APPLICATION NO.	FILING DATE	FIRST NAMED INVENTOR	ATTORNEY DOCKET NO.	CONFIRMATION NO.
10/777,935	02/12/2004	Thomas E. Zion	56689.US	5479

Office Action Summary

ZION, THOMAS E.

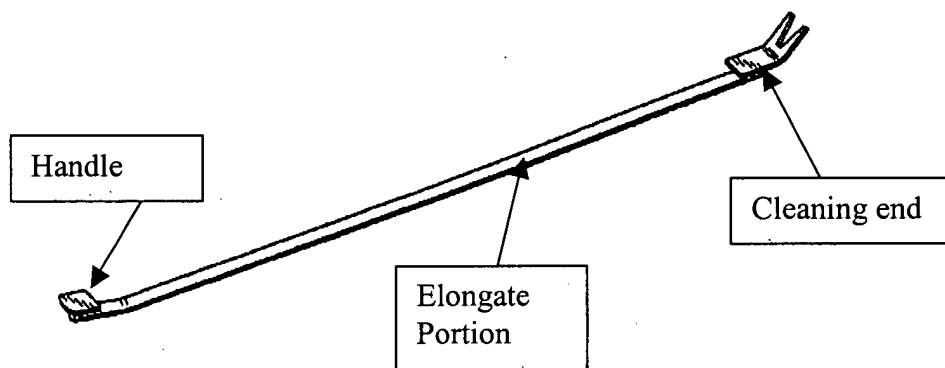
Claims 1, 3, 9 and 18 are rejected under 35 U.S.C. 102(b) as being anticipated by Rostron (USPN D386859).

Rostron teaches a grill cleaning tool comprising a cleaning end with distal and proximal portions. The distal portion of the cleaning ends have a first and second diverging cleaning members, each cleaning member has an inner edge, an outer edge and a terminal end. The proximal portion of the cleaning end is attached to an elongated portion.

With regards to claim 3, the elongate portion has a circular cross-section (figure 7).

With regards to claim 9, the cleaning end is disposed at a first angle to the elongate portion (figure 5).

With regards to claim 18, there is a handle connected to the opposite end of the elongate portion (see figure below).
